PROPOSED TECHNICAL SPECIFICATION

MANAGEMENT TITLE CHANGES

POWER AUTHORITY OF THE STATE OF NEW YORK
JAMES A. FITZPATRICK NUCLEAR POWER PLANT
DOCKET NO. 50-333

SAFETY EVALUATION

FIGURE 5.2-1
 POWER AUTHORITY OF THE STATE OF NEW YORK
 JAMES A. FITZPATRICK NUCLEAR POWER PLANT
 PLANT ORGANIZATION - RADIOLOGICAL ENVIRONMENTAL

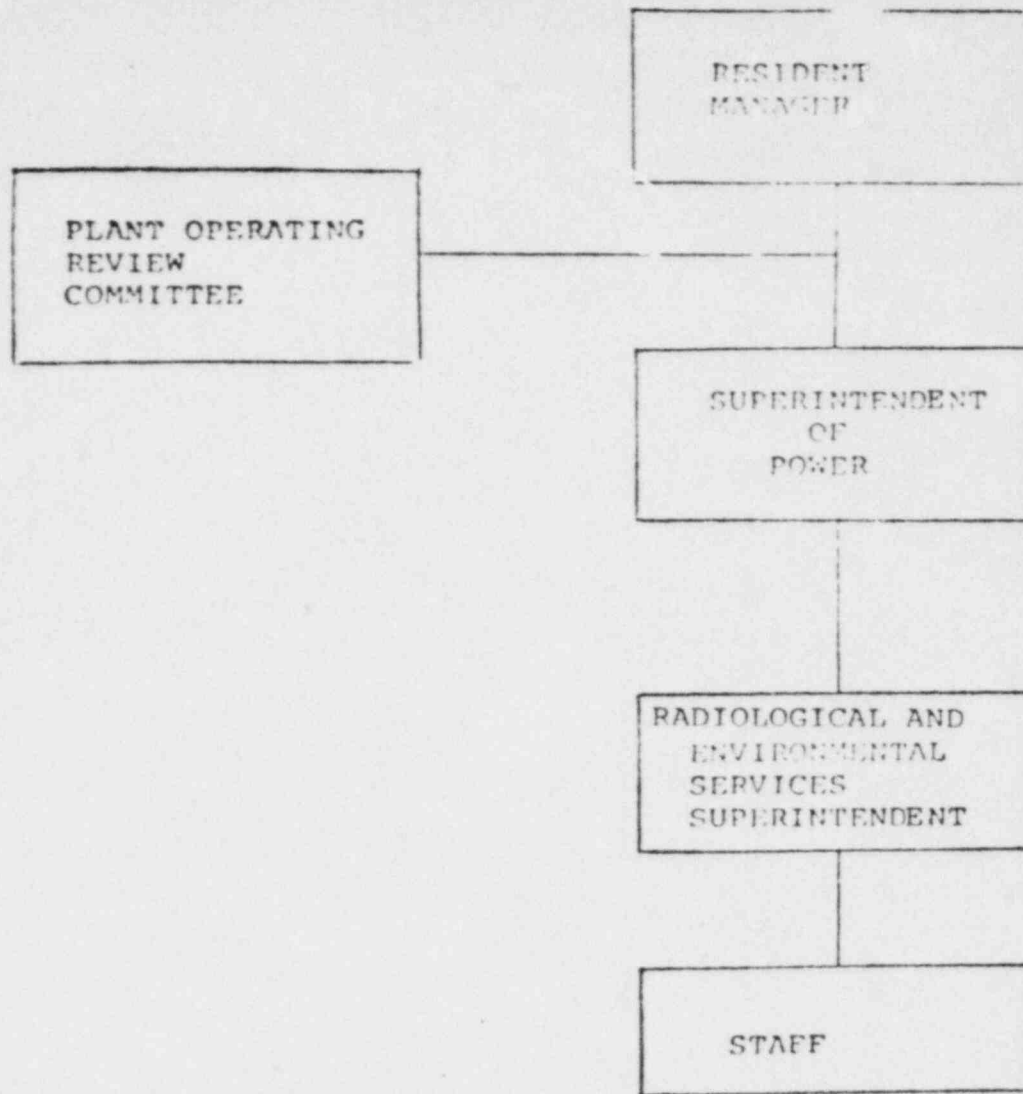
- 1) correcting typographical errors on Figure 5.2-1 Plant Organization to reflect the fact that this chart is for the radiological environmental program only,
- 2) to correct organizational responsibilities and reporting requirements and title changes in Figure 5.2-2 as described in Items 4 and 6 above,
- 3) to reflect the fact that this chart is for the radiological environmental program only by the deletion the Director-Environmental Programs and the addition of the Manager-Radiological Health and Safety.

FIGURE 6.1-1

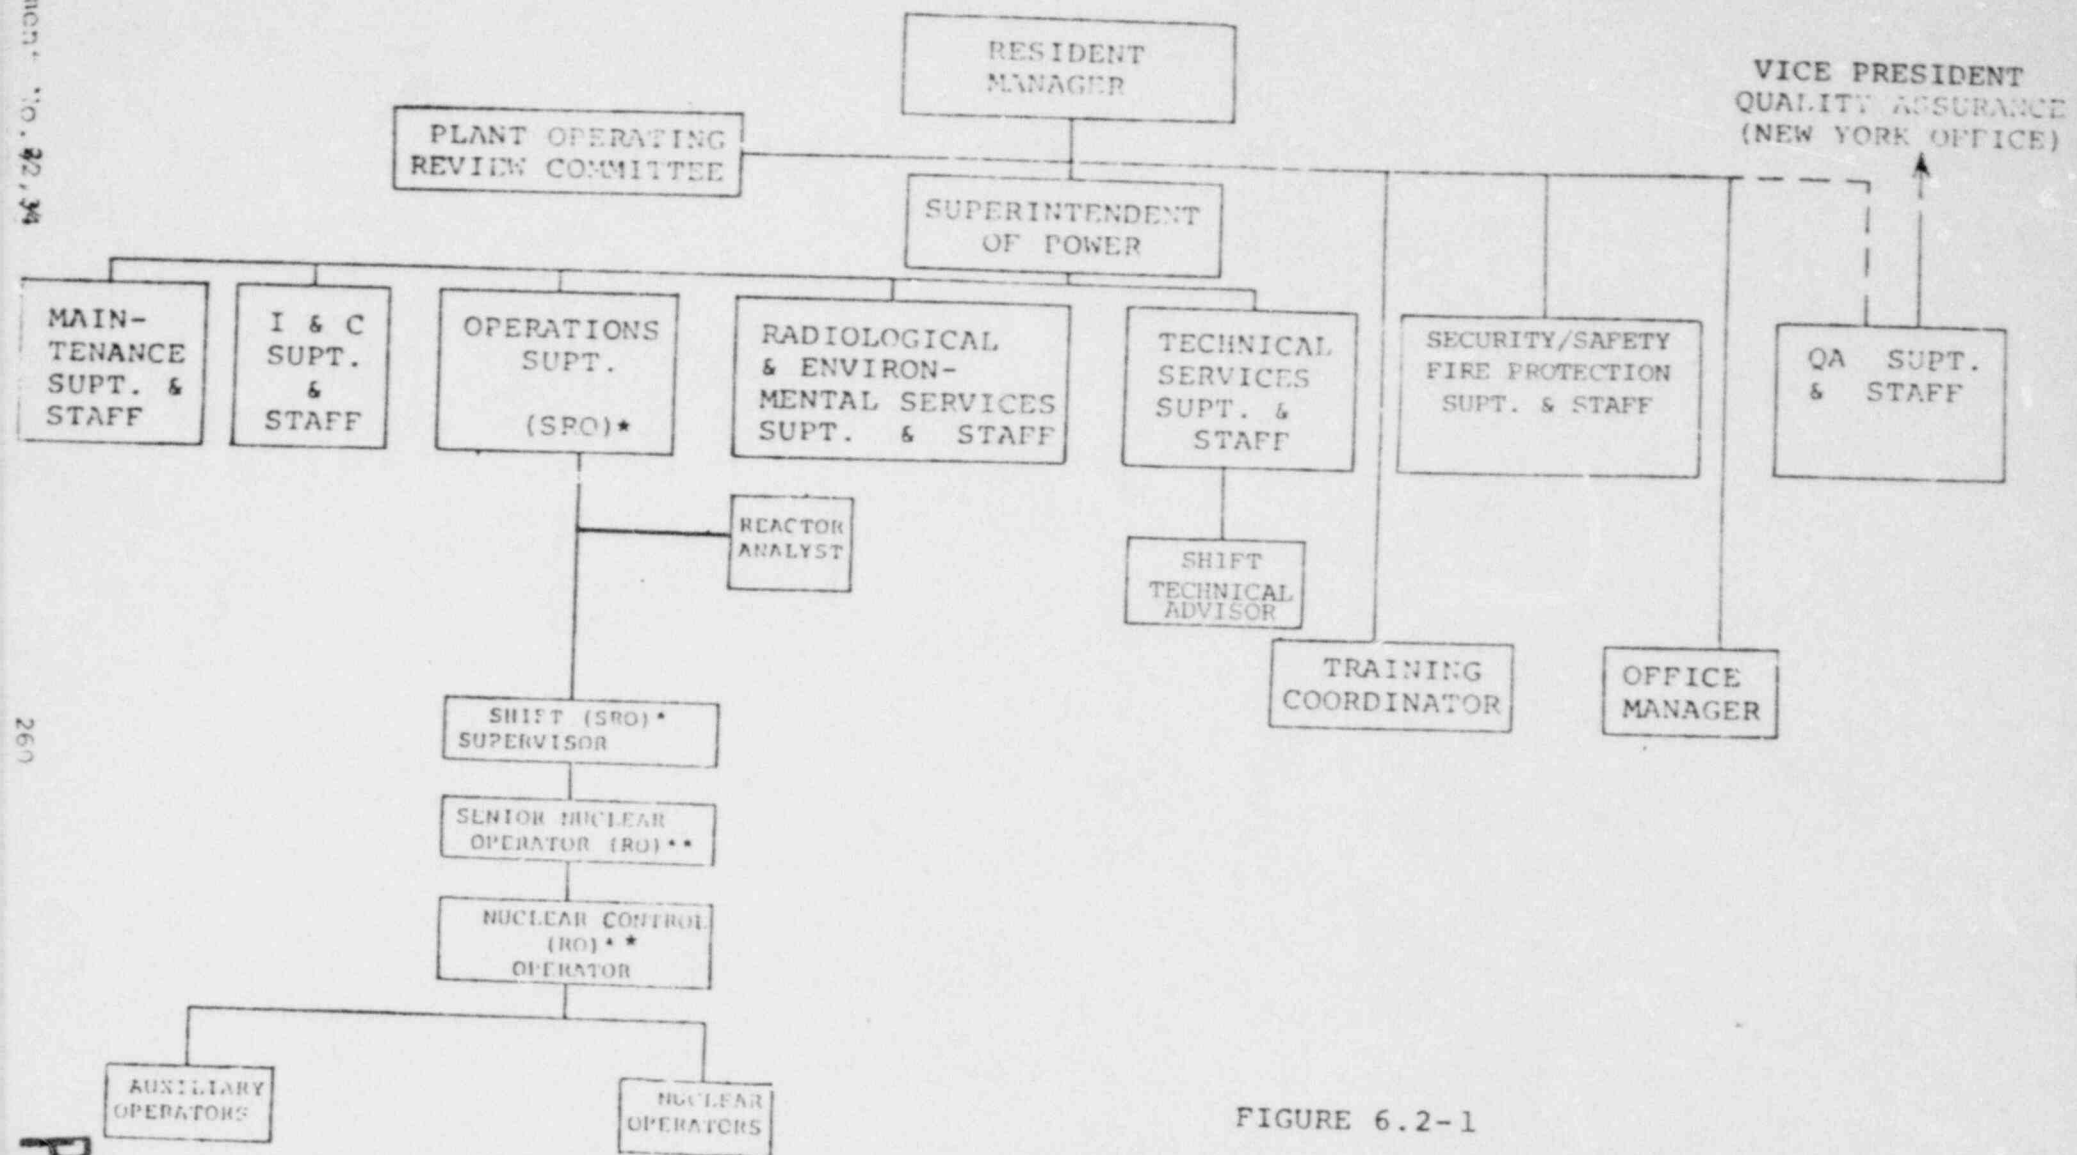
- 3) adding Emergency Planning as a new area of SRC competence,
- 4) deleting the position of Executive Vice President and Director of Power Operations from the Management Organizational Chart (Figure 6.1-1),

- 5) changing the titles of several positions shown on the Management Organizational Chart (Figure 6.1-1),
- 6) changing the reporting requirements of the Senior Vice President Nuclear Generation and the Safety Review Committee to the President and Chief Operating Officer,

- 7) adding the position of Executive Vice President-Procedures and Performance to the Management Organizational Chart (Figure 6.1-1) and the Director of Safety and Fire Protection who is responsible for the Power Authority direction of the Fire Protection Program,
